MPE720 improvement item and bug fix change

Items added and features improved from MPE720 version 5.36 to version 5.37 are as follows.

No.3 A-Net/A-Link module addition

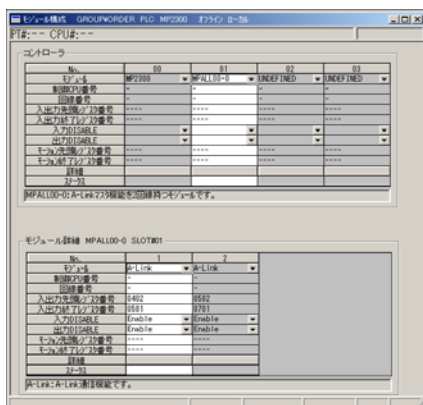
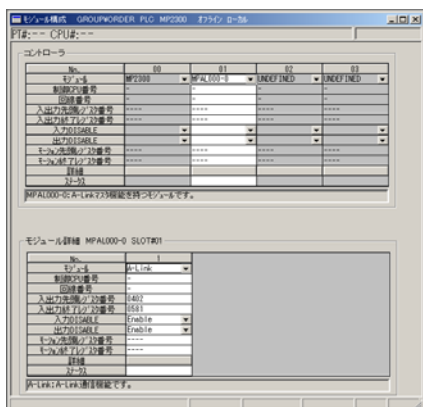
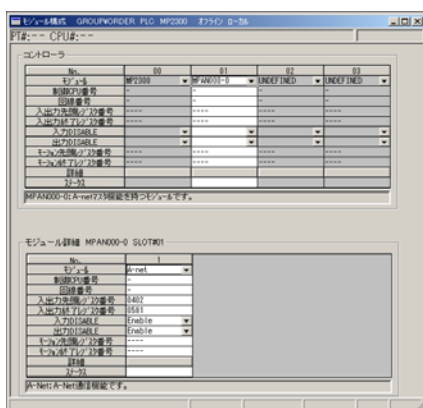
The following three modules that were the sisters modules of MPALN00-0 that had already been released were added as a new module made of ALGO System.

- MPALL00-0 (A-Link x2)

- MPAL000-0 (A-Link x1)

- MPAN000-0 (A-net x1)

No.4 A-Net/A-Link specification change

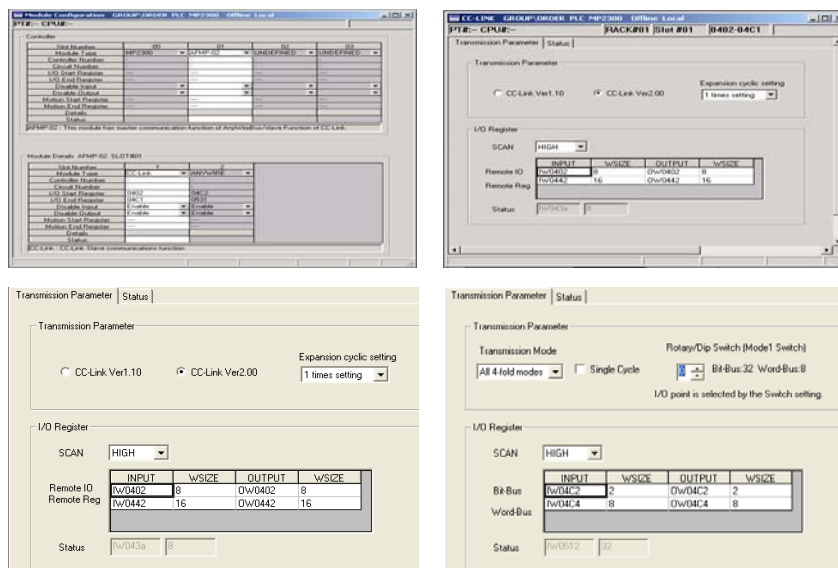
It corresponded to this because it had been changed as reported the status specification of A-Net/A-Link of an existing AFMP-00 module to be a current area of 3W/5W along with the new module addition to the area of 4W/4W.

No.7 Transferring message improvement

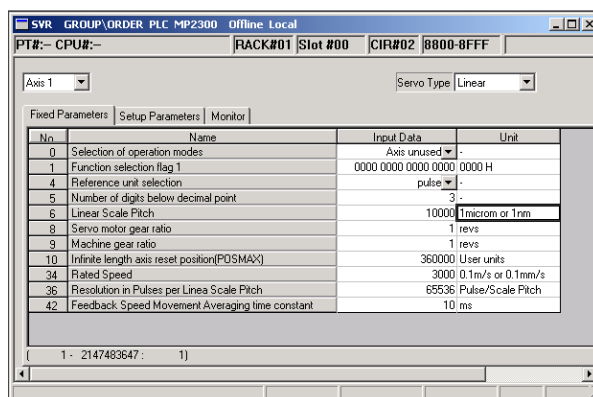
For high-resolution evaluation SVR

No.9 Motion parameter addition

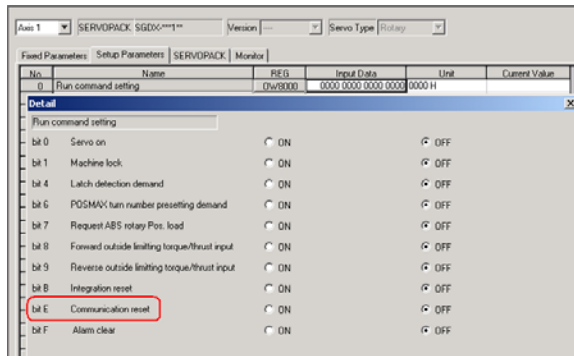
1. It is bit14 in configuration parameter "Run command setting" (OWxx00): "Communication reset" is added.

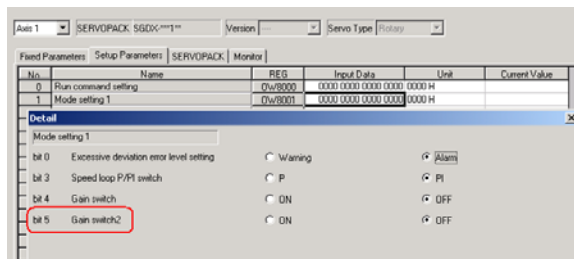
2. It is bit5 in configuration parameter "Mode setting 1" (OWxx01): "Gain switch 2" is added.

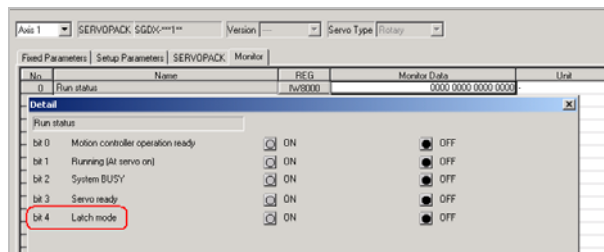
3. It is bit4 in monitor parameter "Run status" (IWxx00): "Latch mode" is added.

No.10 Motion command addition

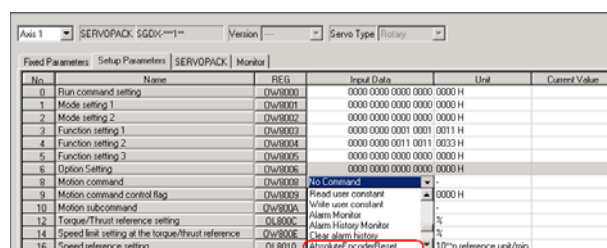
"Absolute Encoder Reset (CMD=22)" was added to the motion command
